Solid Absorber Status

Update since last Collaboration Meeting

Flat LiH absorber mounting

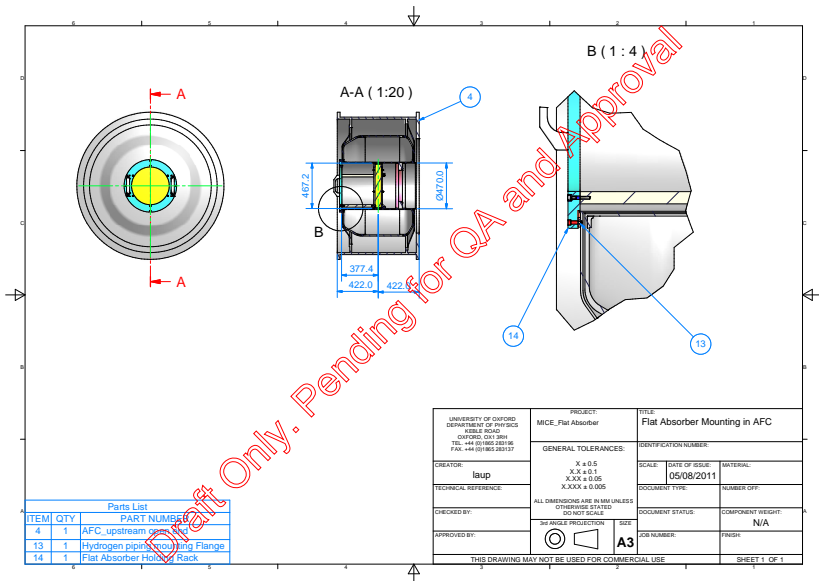
Are we ready to call this design "final"? Any comments, suggestions, concerns?

90 degree wedge absorber support (NEW)

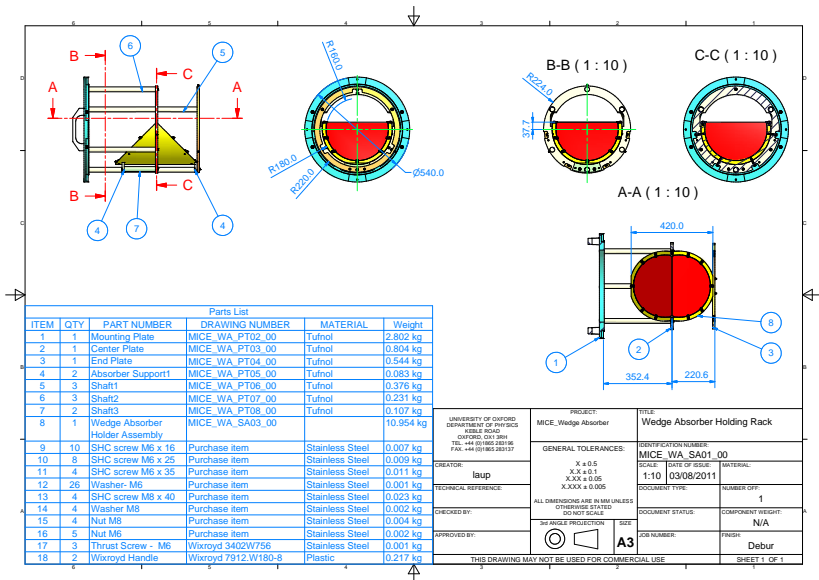
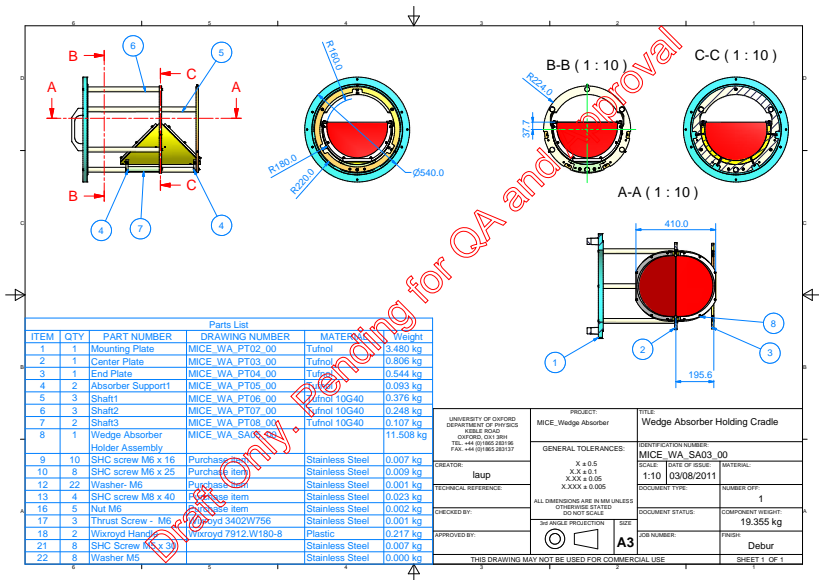
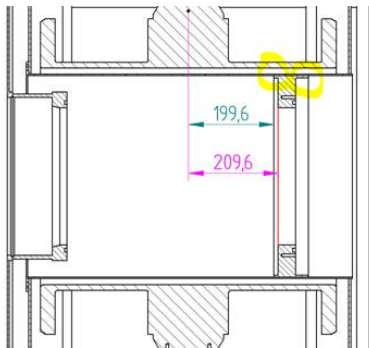
- Notice the change in the absorber holders: small clamps (old) vs arc (compare the two previous slides)
- Before this design can be called final, there are some comments from Jason Tarrant:

Actual downstream flange geometry.

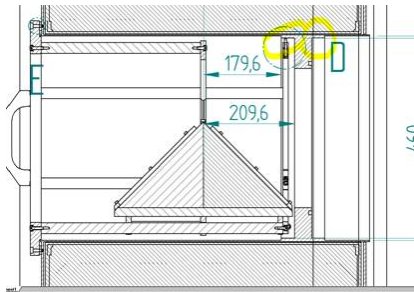
As designed (the downstream ring of the support was supposed to rest against the flange).

45 degree wedge absorber support

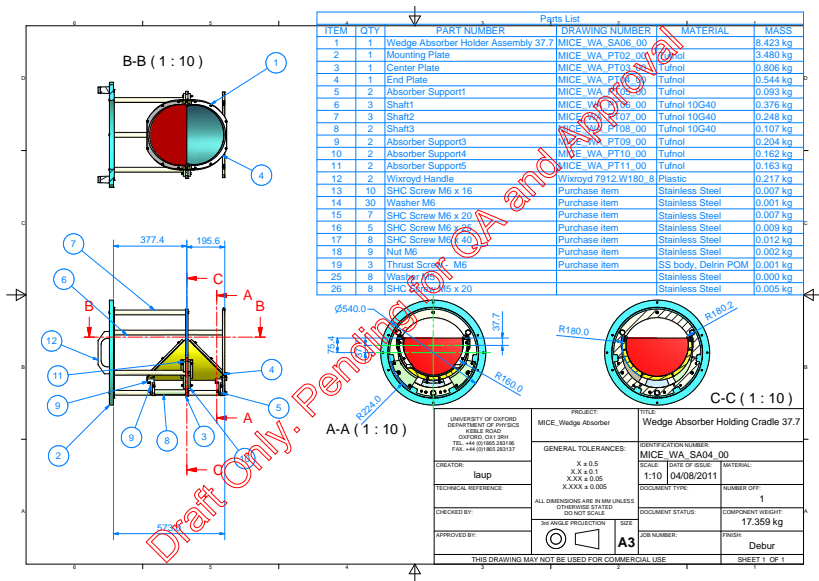
What do we need to do to make the wedge support design final? Any comments, suggestions, concerns?
